NOD SCE ATJ 20211118-01

# NOTICE OF DEFECT

Report Name: SCE\_ATJ\_20211118-01 Inspection Date(s): November 18, 2021

On November 18, 2021, I performed a walking inspection of Southern California Edison (SCE) covered conductor installations, 2021 WMP initiative number 7.3.3.3.1, along Tapo Canyon Road in the city of Santa Barbara, Santa Rosa Road in the city of Camarillo, and various locations in the city of Simi Valley, California. I was accompanied by Energy Safety Environmental Scientist Gary Candelas. Detailed findings from this field inspection are laid out in Section II below.

Item1GW1Img1: Loose guy wire

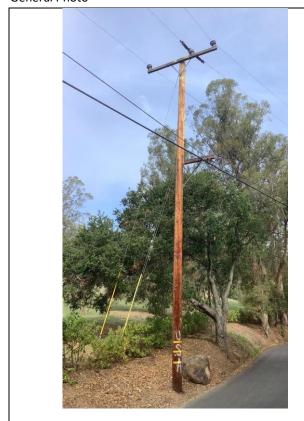
1. Defect 1: Poles numbered 4339409E and 4926384E had loose guy wires. The primary purpose of a guy wire is to provide stability to a structure (e.g., a pole) where imbalanced loads are present. To provide this stability a guy wire must be maintained taut. A loose guy wire increases the risk of structure failure and potential ignition under adverse weather conditions, as the guy wire can no longer serve its intended purpose of balancing an imbalanced load. Energy Safety considers this defect to be in the Minor risk category.

ltem	Structure ID	HFTD	Defect Type	Severity	Defect Description
1	4339409E	Tier 3	Down guy wire loose	Minor	Loose guy wire
2	4926384E	Tier 3	Down guy wire loose	Minor	Loose guy wire

Item7IA1Img1: Porcelain guy insulator

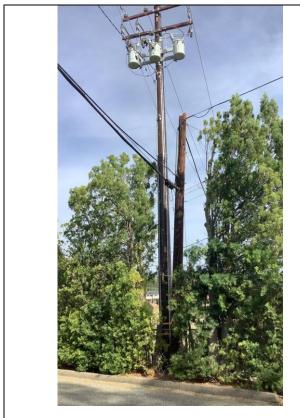
10	4263188E	Tier 3	7.3.3.3.1	Completeness	Moderate	No covered conductor installed	
11	1257280E	Tier 3	7.3.3.3.1	Adherence to Protocol	Minor	Failure to update fiberglass guy strain insulator	
12	4554703E	Tier 3	7.3.3.3.1	Adherence to Protocol	Minor	Failure to update fiberglass guy strain insulator	
13	4554704E	Tier 3	7.3.3.3.1	Adherence to Protocol	Minor	Failure to update fiberglass guy strain insulator	
14	2144971E	Tier 3	7.3.3.3.1	Adherence to Protocol	Minor	Failure to install vibration dampers on a span	
15	2144970E	Tier 3	7.3.3.3.1	Adherence to Protocol	Minor	Failure to update fiberglass guy strain insulator

In accordance with SCE's protocols for covered conductor installation, Distribution Overhead Construction Standards (DOH) PO section 300, SCE states, "In HFRA installations of covered conductor it is required to upgrade down guy/span guy insulation to include Fiberglass Guy Strain Insulators." In addition, SCE's Distribution Design Standards (DDS), section DDS-10 indicate that, "Beginning July 2020, SCE has transitioned to a standard requirement in guying to utilize the fiberglass guy strain insulators where traditional porcelain guy strain insulators have been applied." Further, in response to Energy Safety Data Request (DR-030), SCE stated "In HFRA installations of covered conductor it is required to... upgrade down guy/span guy installation to include Fiberglass Guy Strain Insulators." During the inspection, Energy Safety found several instances where fiberglass guy wire strain insulators were not installed where covered conductor work was completed, per SCE's protocols. Structures where this protocol was not followed are noted in Table 2 above.
